**PLANNED UNIT DEVELOPMENT &
PLANNING APPROVAL STAFF REPORT**

Date: September 17, 2009

St. Luke's Episcopal Upper School

1400 South University Avenue
(South side of University Boulevard, 490'± East of Grelot Road)

SITE PLAN

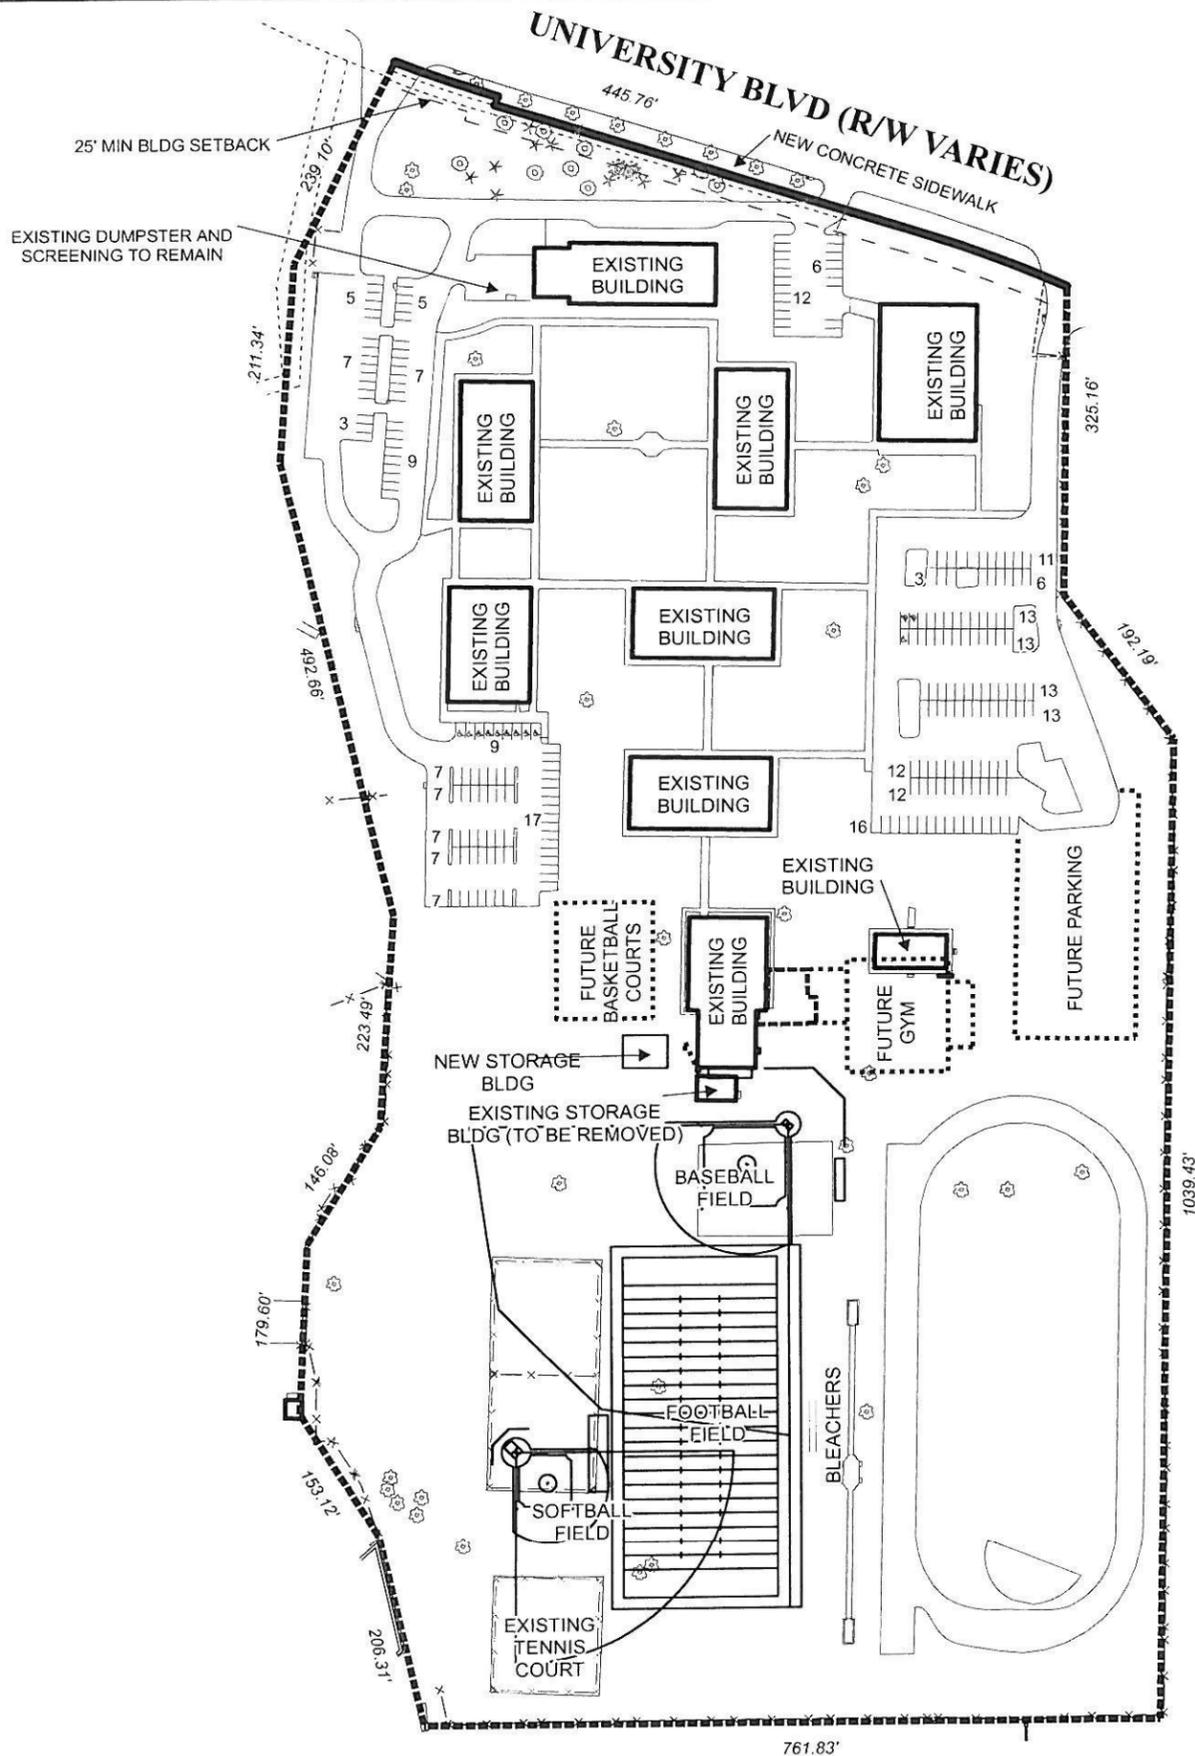
As mentioned previously the site plan illustrates a “future gymnasium and basketball courts”. A separate Planned Unit Development (PUD)/Planning Approval application will be required for these additions, or the current applications should be heldover and revised.

No on-site storm water detention facilities are depicted on the site plan, however such facilities may be required due to the extent of the proposed new development.

There is indication on the site plan as to the existing location of the dumpster or other waste storage facility. The location of the storage area for the dumpster is indicated on the site plan, required screening must comply with Section 64-4.D.9. of the Zoning Ordinance, as well as with all other applicable regulations.

Regarding compliance with the tree and landscape requirements of the Zoning Ordinance, the applicant illustrates a significant number of frontage trees along South University Boulevard; however, no percentage of frontage landscaping is illustrated. Since no addition is illustrated or proposed within the front of the existing buildings and the total existing landscaping of 70 percent greatly exceeds the minimum requirements of the Ordinance, the approval should be approved based on the percentage of front landscaping that exists today.

As the reorientation of the softball field, new baseball and football fields may effect adjacent residences, the applicant should be aware that these fields would only be used during daylight hours since light standard design, placement and photometric were not included with the application.

- 1) *placement of a note on the site plan stating that an 8-foot high privacy fence shall be provided, with appropriate permits, as a buffer around the perimeter of the campus abutting R-1 zoned properties. The fence to be completed prior to the football, baseball and softball fields;*

- 2) *the provision of a 20-foot vegetative buffer providing three rows of trees staggered thirty feet in each row. Tree species to be coordinated with Planning and Urban Forestry;*

- 3) *lighting of parking facilities shall be provided in compliance with Section 64-6.A.3.c of the Zoning Ordinance;*
- 4) *provision of consultation with Engineering Department on the placement, design and construction of the sidewalks along University Boulevard South prior to October 15, 2010;*

- 5) *Compliance with Engineering comments (Must comply with all storm water and flood control ordinances. Detention must be provided for any increase in impervious area added to the site since 1984 in excess of 4000 square feet. Any work performed in the right of way will require a right of way permit);*

- 6) *illustration of any additional dumpster or trash receptacle, with **minor** revisions to parking and circulation layout to be approved by Planning staff, if necessary;*

- 7) *submission of a revised site plan reflecting the conditions prior to the issuance of any permits; and*
- 8) *full compliance with all other municipal codes and ordinances.*

MASTER PLAN

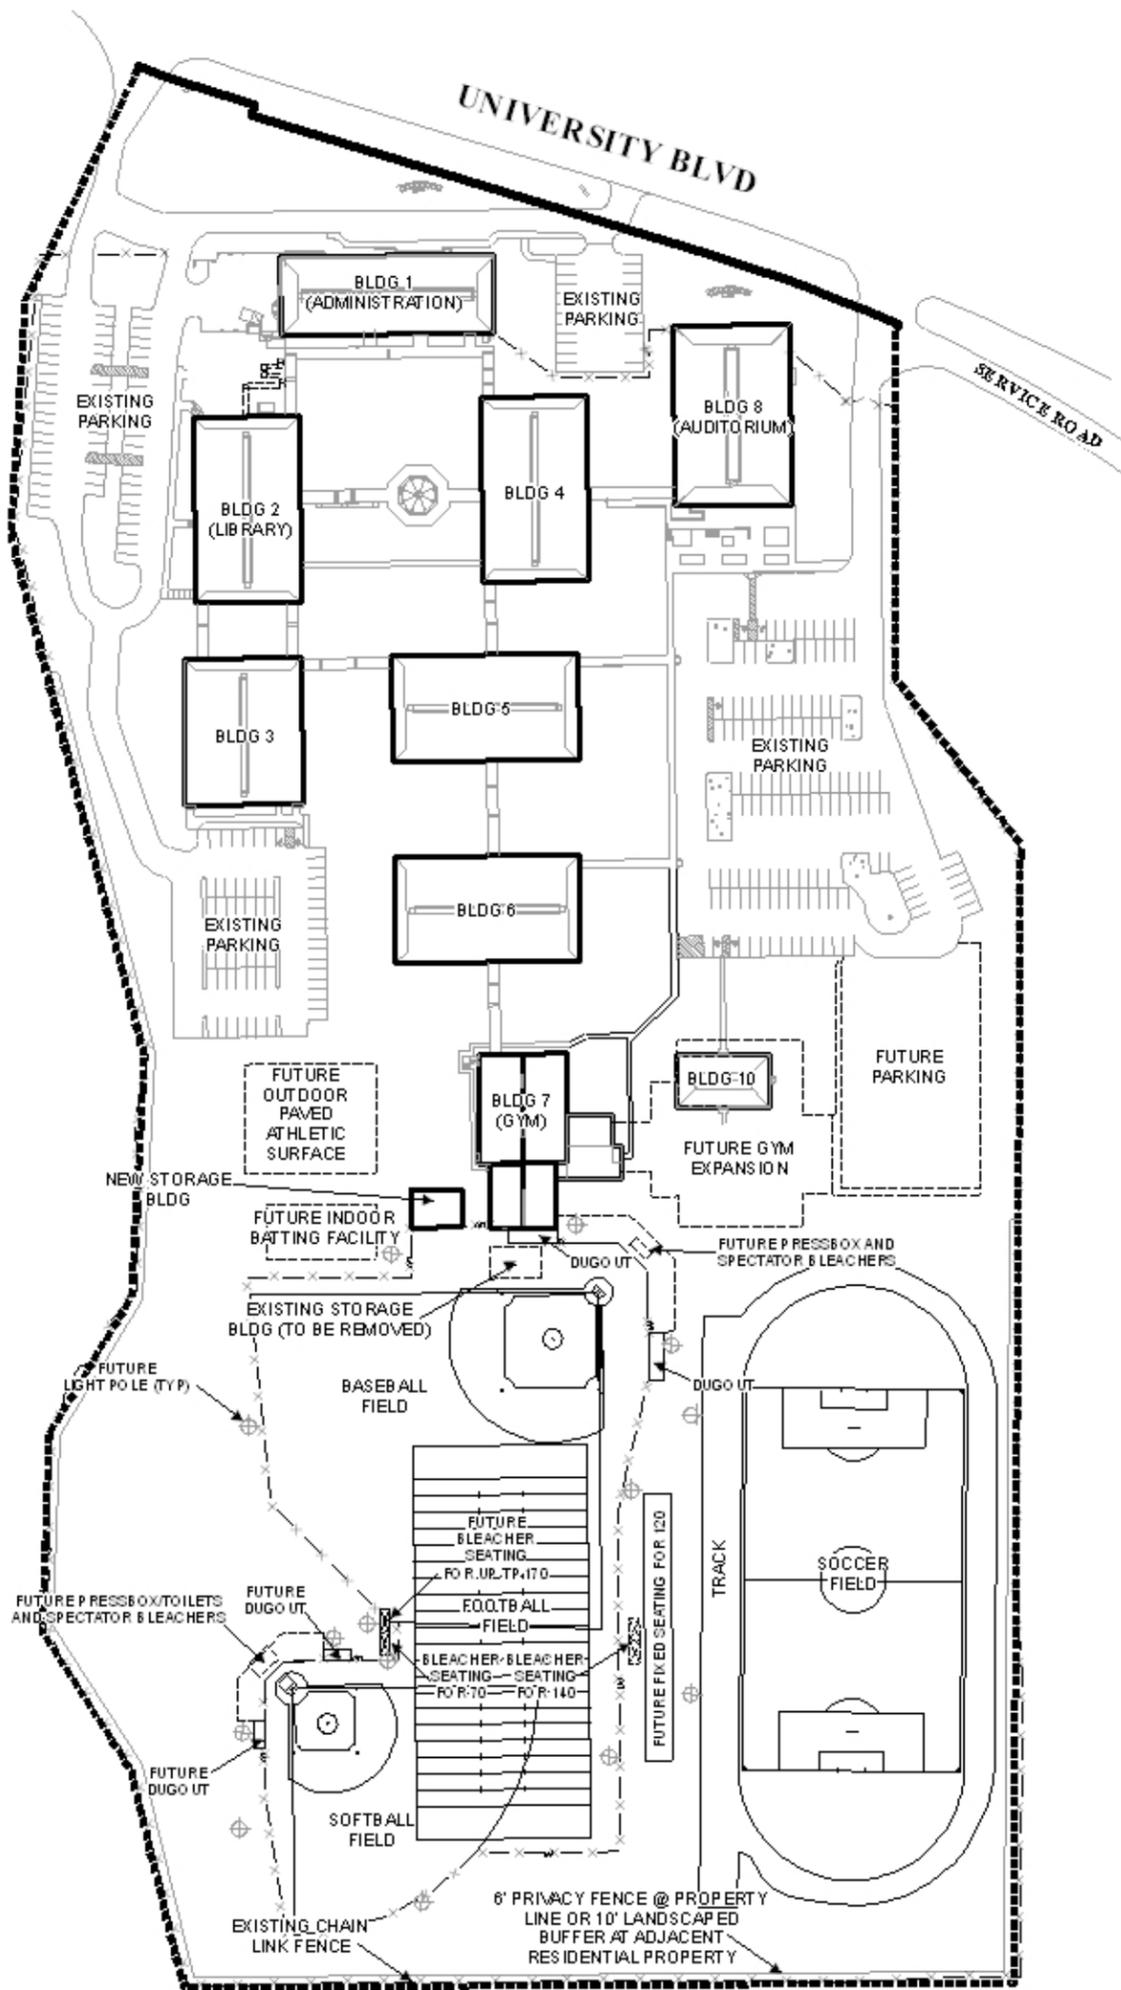
The applicant submitted a Master Plan as required by the Commission at the September 17th meeting. The detailed master Plan illustrates fifteen light standards, arranged along the outside perimeters of the soccer, baseball, football and softballs fields. The future plan illustrates permanent seating for 1,200 on the East side and 170 on the West side of the football field. Future spectator seating, press boxes and restroom facilities are also illustrated for the baseball and softball fields. Also, the applicant has illustrated a building addition associated with athletics, such as a future indoor batting facility, expansion of the existing gymnasium and associated parking facilities to complement the activities as proposed.

The applicant does not wish to amend the previously submitted Planned Unit Development (PUD) and Planning Approval but is illustrating the future layout of the athletics fields as the applicant envisions the campus in the future.

Concerning the buffer separation staff suggests that the applicant be required to provide an 8-foot solid wooden privacy fence along the perimeter abutting all R-1 zoned properties along the West and South side of the site as practicable and a 20-foot vegetative buffer providing three rows of trees staggered thirty feet in each row along the West and South side of the site, with the tree species to be coordinated with Planning and Urban Forestry.
